IEEE 802.3da SPMD:
MPOE: Multiple MPIs per DTE

Peter Jones, Cisco Systems
May 2025

1.1 Goals: Reporting and controls for MPoE systems

Figure 189-1a - Example MPI to DTE associations

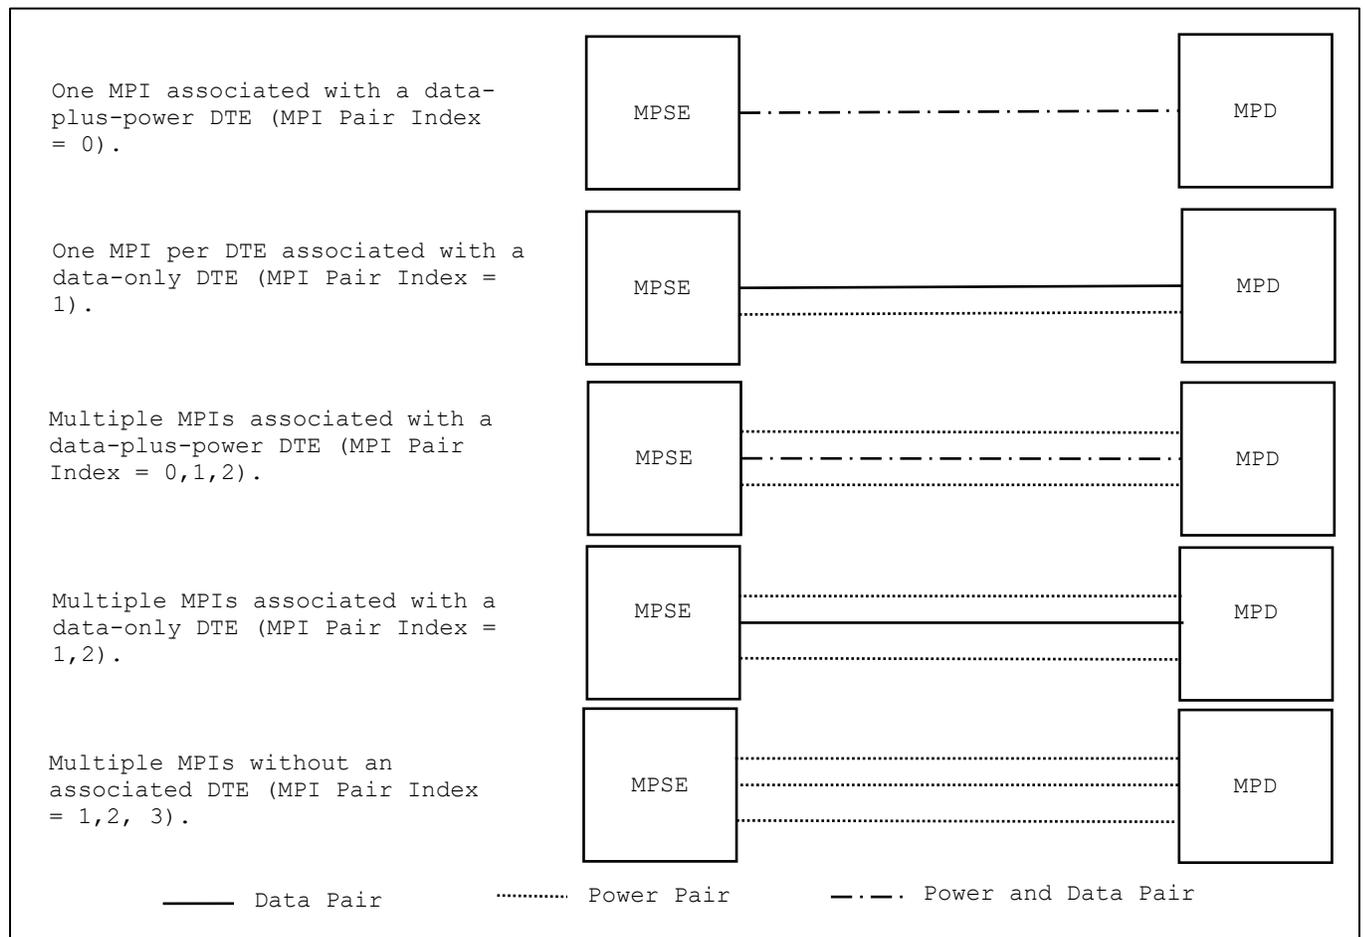
Add the following text after Figure 189–1 in 188.1.2

189.1.2a MPI and DTE association

Figure 189-1a below illustrates (showing only two nodes for simplicity of drawing) some of the different types of MPI and DTE associations supported by MPoE.

189.1.2a.1 MPIs associated with a DTE

A DTE may be associated with 0, 1 or more than one MPIs. A DTE with 0 associated MPIs is a data only link. A DTE often has an MPI sharing the same power/data pair.

The set of MPIs associated with a DTE shall meet the following criteria:

- MPIs for a given DTE are either all MPSEs, or all MPDs.
- Unless stated otherwise, all other MPI attributes for a given DTE are independent. This includes:
 - MPI type
 - MPI capabilities and status
 - MPI requested and granted power
